## ADDENDUM NO. 1

TO: PLANS AND SPECIFICATIONS FOR STATE OF MISSOURI

*REBID, St. Clair Readiness Center-Renovate Interior & Exterior*  
375 S. Commercial Ave., St. Clair, MO 63077  
PROJECT NO. T232601

H. Hardware Set 8: Each door to have the following:

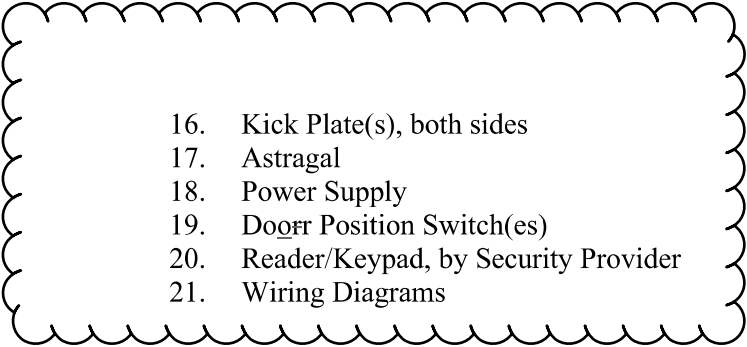
- a. All Infrastructure need to be done as part of the base-bid and not of the Alternate, Just the kitchens equipment's.
8. The hardware schedule includes opening numbers not listed on the door schedule. Openings 108, 104, 105a, 105b, 103b, 109, 103a, 110a, 103c, 107 are not listed in the door schedule. Should we ignore these openings? I'm assuming so.

Hardware set 8 includes openings 100a, 113, 118b, 120b that have different opening sizes, and some are pairs. These openings are confusing since it indicates multiple locksets including an office lockset and an electric lockset. I'm just looking for some clarification on the opening hardware as it corresponds to the access control and the singles vs pairs.

Can you see if they will define these openings better in the hardware sets, identifying which openings are to have access control, the type of locking device that is applicable to the singles and the pairs, etc. This is the pricey portion of the hardware, so I want to make sure we get it right.

- a. Please refer to the updated door schedule in A700
  - b. Door hardware specification was updated.
9. The bid docs call out an Alternate, which at the walkthrough, we were told it is for "kitchen equipment" only. Does kitchen equipment include the new hood, make up air unit, exhaust grease fan, and associated ductwork, or just cabinetry, etc., shown on the Food Service drawings. Also, who is supposed to supply the Food Service equipment, and specifically the hood? The hood is shown on the Food Service drawings equipment schedule, but the make up air unit and fan are on the mechanical equipment schedule. I'm just trying to figure out the scope to price and break out as the Alternate.?

1. DOORS: ~~100A, 103A, 110A, 113B, 118B~~, 120B
2. Continuous Hinges
3. ~~Entry Lockset~~
4. ~~Electric Lock~~
5. Power Transfer(s)
6. Electrified Lockset
7. Cylinder
8. Threshold at exterior door
9. Weatherstrip
10. Closer
11. Kick plates both sides
12. Rain Drip
13. Power Supply
14. Door Position Switch(es)
15. Reader/Keypad, by Security Provider
16. Wiring Diagrams

1 FLOOR PLAN

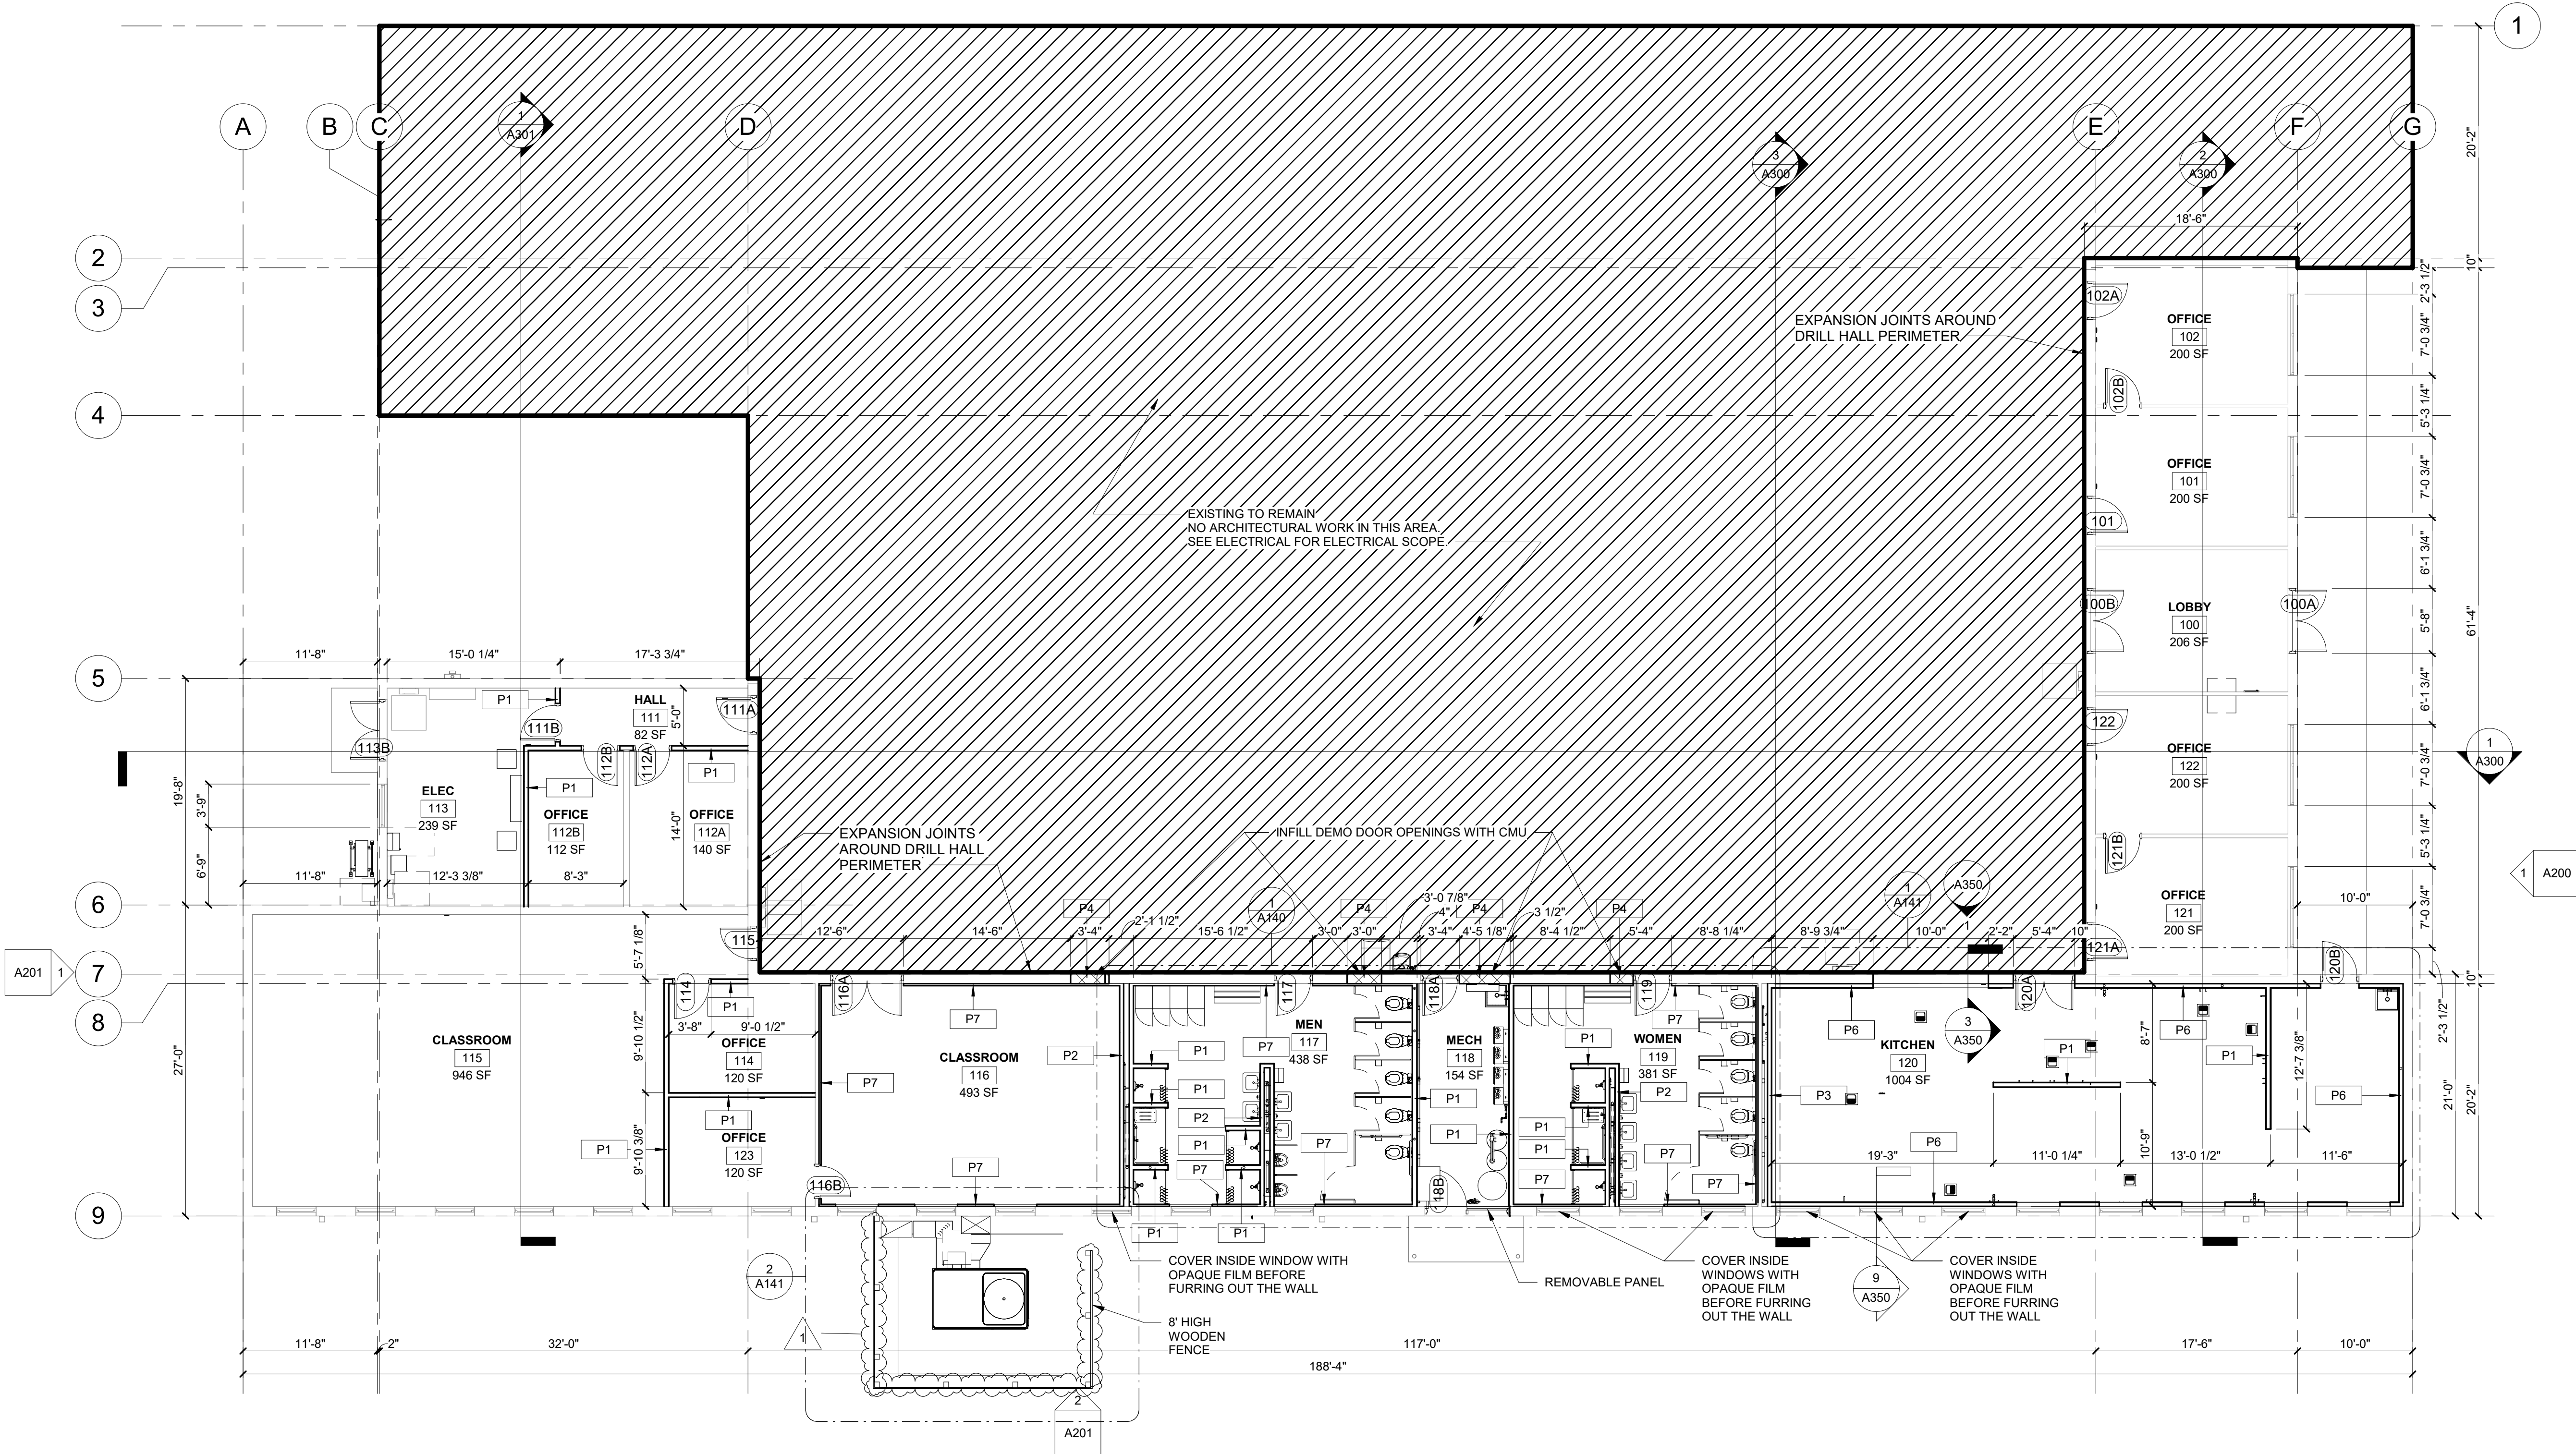
1. Drawing A100:
  - a. *Added slab repair detail*
  - b. *Called out the wooden fence around the HVAC unit*
2. Drawing A141:

27. Is it the intention to saw cut and remove slabs at all the various locations of underground sewer piping shown on sheet P101 or is it preferred that all slabs in those rooms shall be removed in their entirety and replaced?

- a. Either approach, saw cutting and removing only at the specific sewer piping locations or full slab removal in the affected rooms is acceptable. However, whichever method is chosen must fully comply with the design intent and specifications shown on the drawings. See sheet A100 for slab repair details where applicable.

3 DUCT PENETRATION DETAIL  
1/8" = 1'-0"

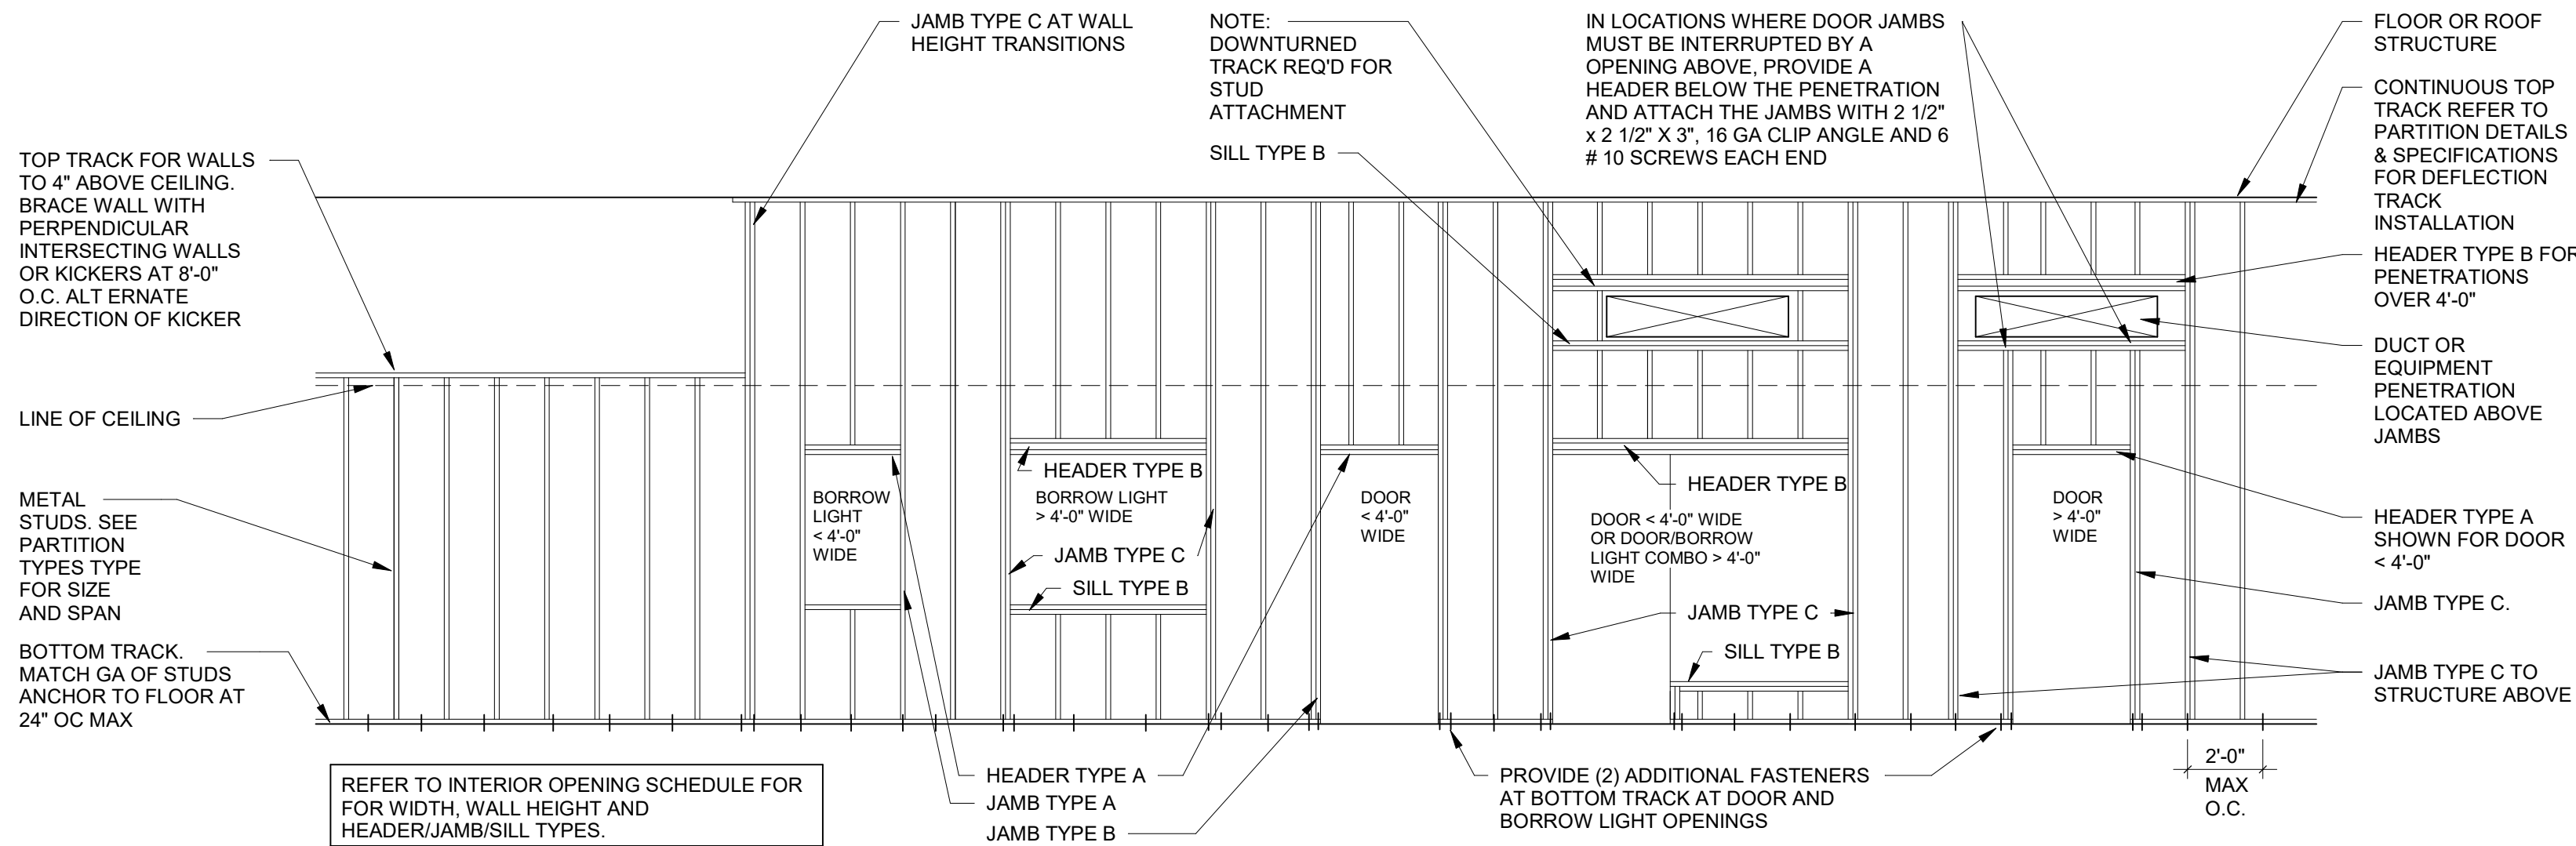
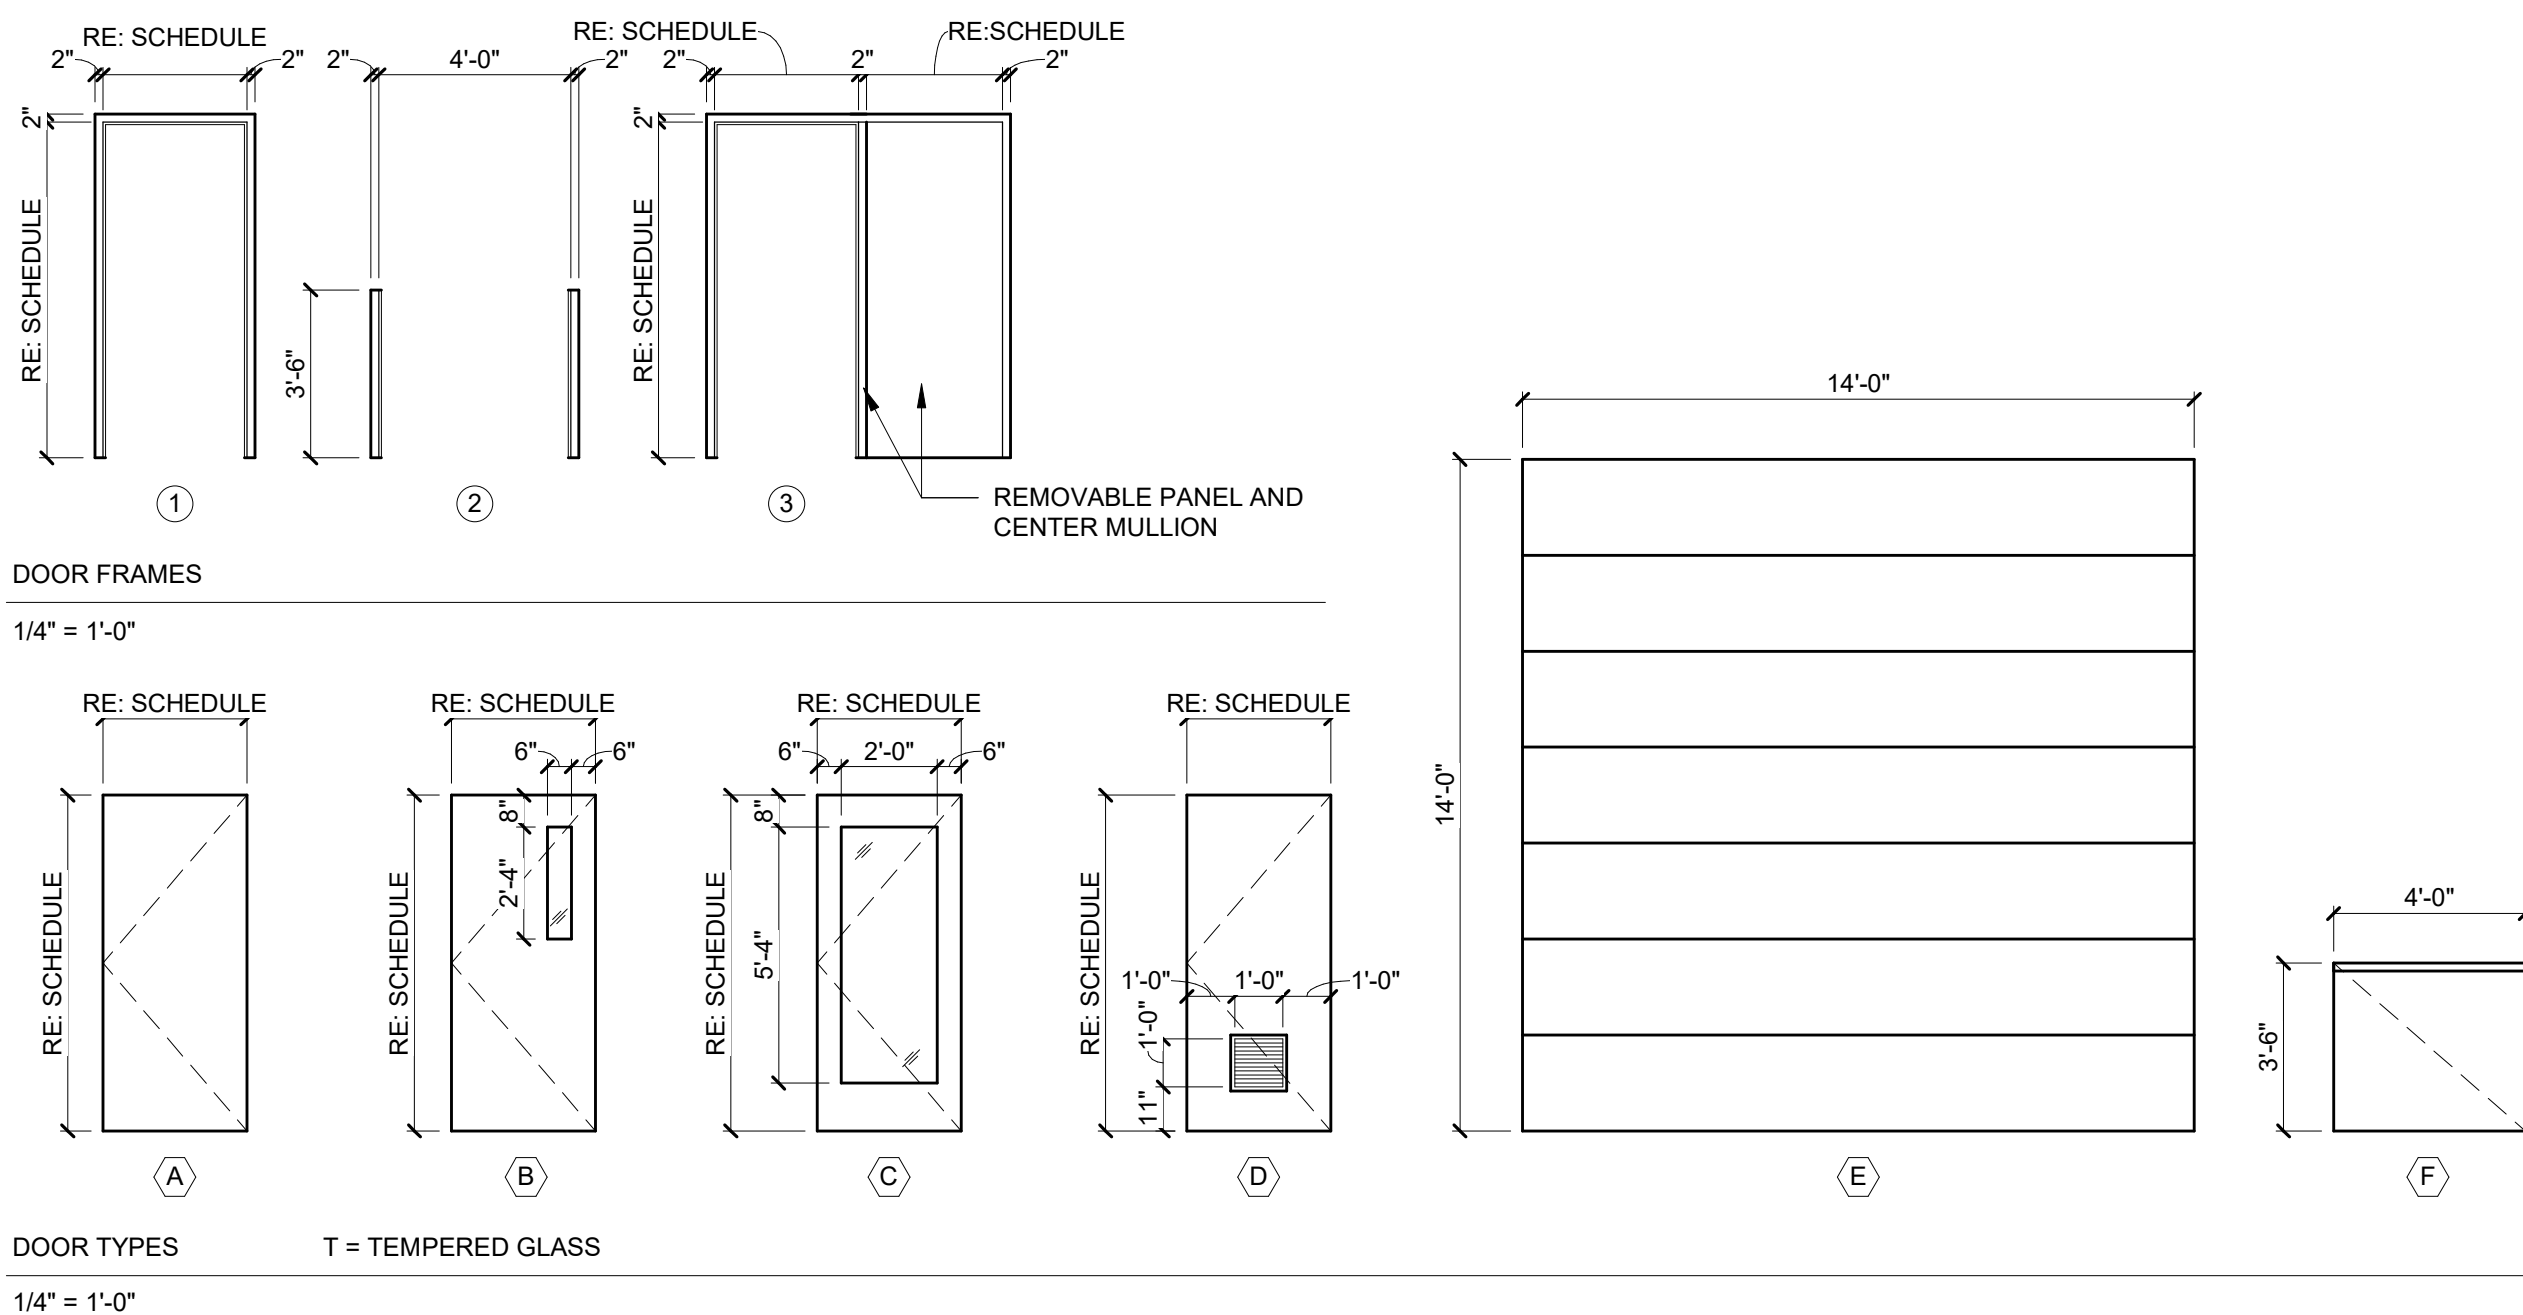
- a. *Added detail for the wooden fence around the on-ground HVAC unit.*
- 3. Drawing A201:
  - a. *Added detail for duct penetration*
- 4. Drawing A700:
  - a. *Updated the door Schedule*
- 5. Drawing A800:
  - a. *Updated the room finish schedule*
- 6. Drawing C101:
  - a. *Updated the scale on the sheet and modified Notes 1 & 2*
- 7. Drawing C501:
  - a. *Called out the aggregate base type*
- 8. Drawing E701:
  - a. *Called out note regarding the existing and new electric meter*
- 9. Drawing M601:
  - a. *Added more notes about the controllers.*
- 10. Drawing M701:
  - a. *Notes added about the VAV*

26. Will there be a new opening for the HVAC duct between the new, exterior pad equipment and the new interior duct servicing the classrooms and offices; if so, is it located as shown on 1/M301 between existing windows?

- a. Yes, there will be new openings for HVAC ductwork through the exterior wall. it is located as shown on M301 between existing windows, See updated sheet A201
